NEEDHAM PLANNING BOARD Tuesday, February 2, 2021 7:15 p.m.

Re: Definitive Subdivision Application

390 Grove Street

STORMWATER REPORT & DEFINITIVE PLAN COMMENTS

2020-12-07

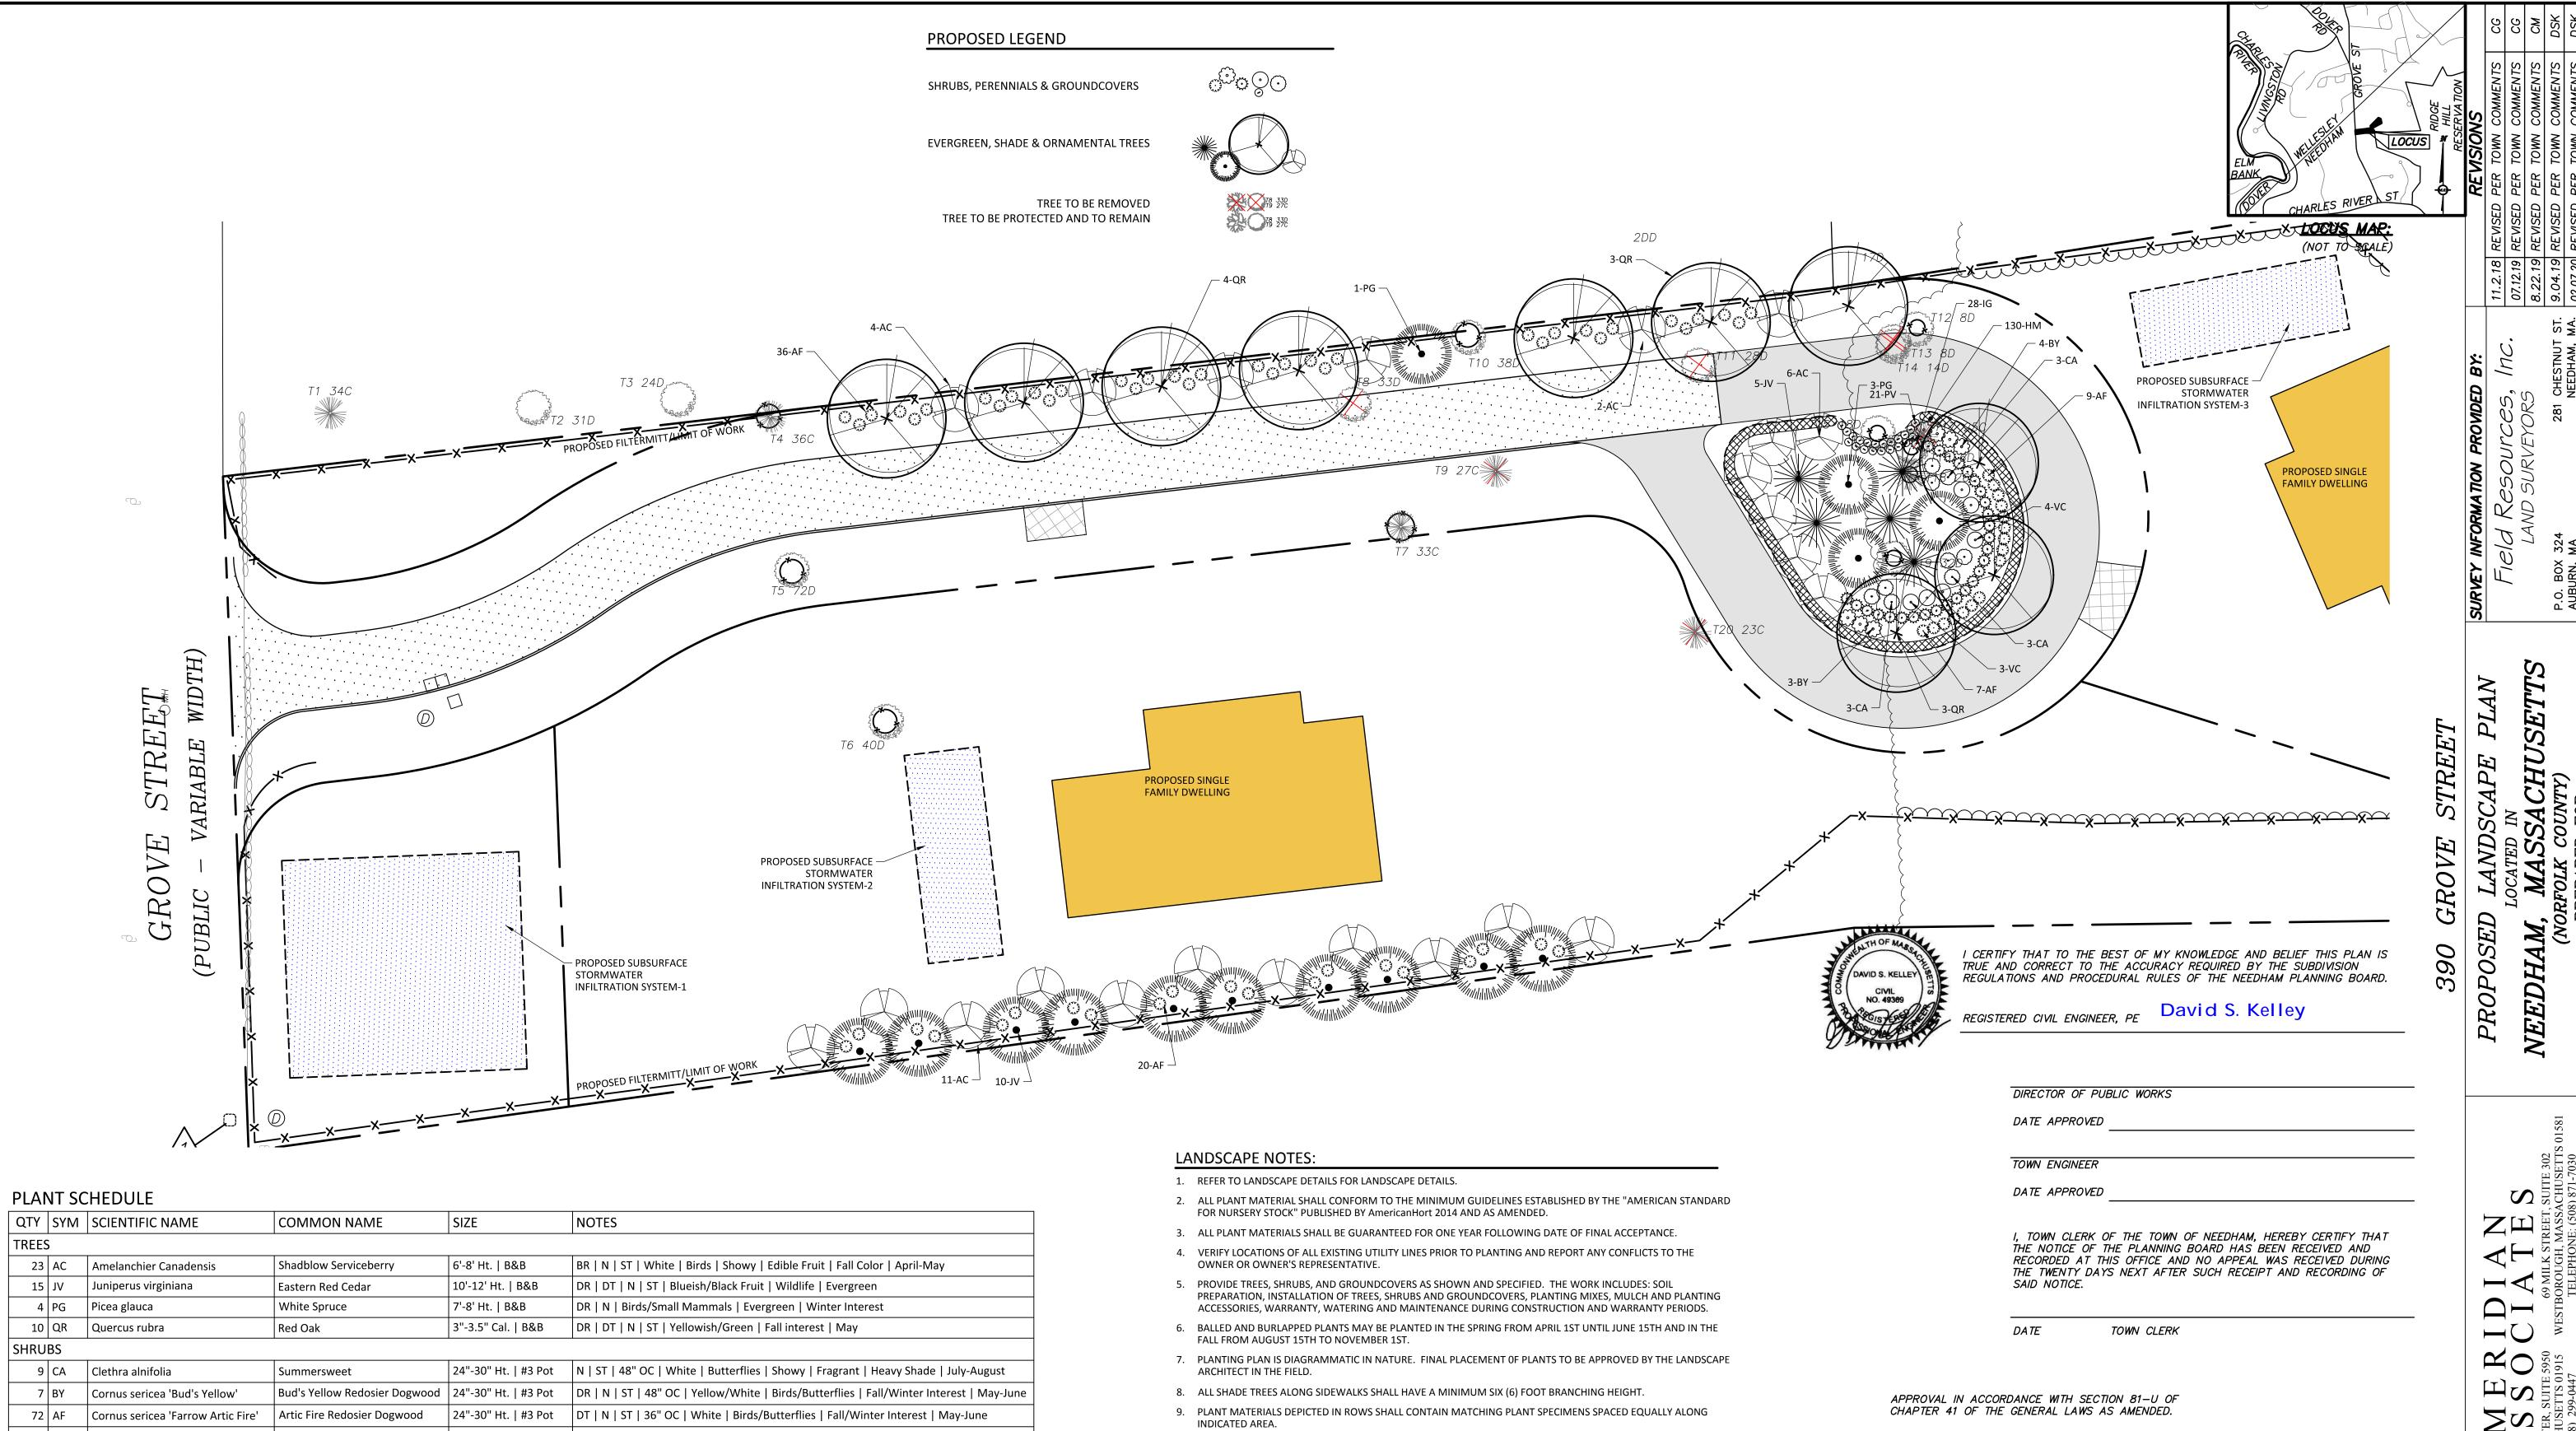
2. Per section 3.3.4 of the subdivision regulations, "Street jogs with centerline offsets of less than 125-ft, streets with varying widths and reverse curves shall be avoided." The By Right Subdivision Plan (sheet 3 of 10) and Proposed Site and Grading Plan depict a street centerline jog of approximately 30-ft at the intersection with Grove Street along with a reverse curve in order to achieve this jog both of which are in conflict with the subdivision requirements.

4. Per Section 3.3.1 of the subdivision regulations, "The grade of a street within 50-feet of a street intersection shall not exceed 1% to provide a level area for traffic safety." The Proposed Utilities & Profile Plan (Sheet 6 of 10) identifies that the road contains only a 20-foot long section of roadway that has a slope less than 1%, which is less than the 50-foot requirement.

9. The By Right Subdivision Plan (Sheet 3 of 10) does not depict proposed grading or stormwater management features that would be required for the design as depicted on the by-right plan. Additionally, the proposed sidewalks depicted on this plan are very close to the existing trees to

10. The By Right Subdivision Plan (Sheet 3 of 10) and most of the other plans identify both buildable parcels as Lot 1 and there is no Lot 2. This needs to be corrected.

11. The Lotting Plan (Sheet 4 of 10) has a number of significant inconsistencies with the remainder of the Definitive Plans. These include the following: identifying Parcel B as part of Lot 2 at the end of the proposed roadway, whereas the remainder of the Plans identify Parcel B as the remnant parcel north of the subdivision roadway parcel; identifying the remnant parcel south of the subdivision roadway as Parcel A, whereas the remainder of the Plans identify this as Parcel B; not labeling the remnant parcel north of the subdivision roadway. The Lotting Plan as presented is not complete or accurate and cannot be approved as currently presented.

15. The top of stone for Infiltration System 1 is proposed at elevation 200.3 per the details on Sheet 10 of 10. The minimum proposed finished grade above the chambers is identified to be elevation 201.33. The grading depicted on the Proposed Site & Grading Plan (Sheet 5 of 10) appears to indicate the top of chambers is slightly higher than elevation 200, but not above elevation 201 which would not provide the required amount of cover. The surface grades are proposed to slope down immediately adjacent to the proposed stormwater chambers with the surface grade less than the top of stone within approximately 5-ft of the chambers. Additionally, the bottom of chambers is proposed above the existing street grade along Grove Street. The Applicant should confirm there will not be breakout along Grove Street. The grading in the vicinity of the Infiltration System 1 and size of Parcel "B" should be reviewed to confirm this parcel has sufficient size and the drainage system is feasible as proposed.

19. The Proposed Utilities & Profile Plan (Sheet 6 of 10) shows an 8x8x6 tee connection to the existing 8" water main for the proposed 8" water main. This connection is inaccurate as it does not appear that a 6-inch pipe is proposed in this location. Additionally, the waterline appears to have less than 5-ft of cover from station 10+50 to 11+50. This should be addressed.

20. The profile included on the Proposed Utilities & Profile Plan (Sheet 6 of 10) depicts a proposed grade of 3.3% presumably along the centerline of the roadway, although the profile line appears to have a number of grade breaks at approximate stations 10+20 and 11+40. There is no information included regarding these apparent grade breaks. Furthermore, a 20-ft vertical curve is identified from station 10+00 to 10+20, although the profile appears to indicate that the centerline grade at this location is set at a uniform slope of 0.5%. These inconsistencies should be addressed.

21. The Revision Block on the Record Conditions Plan of Land (Sheet 2 of 10) is unclear and has overlapping text. This should be corrected for the record.
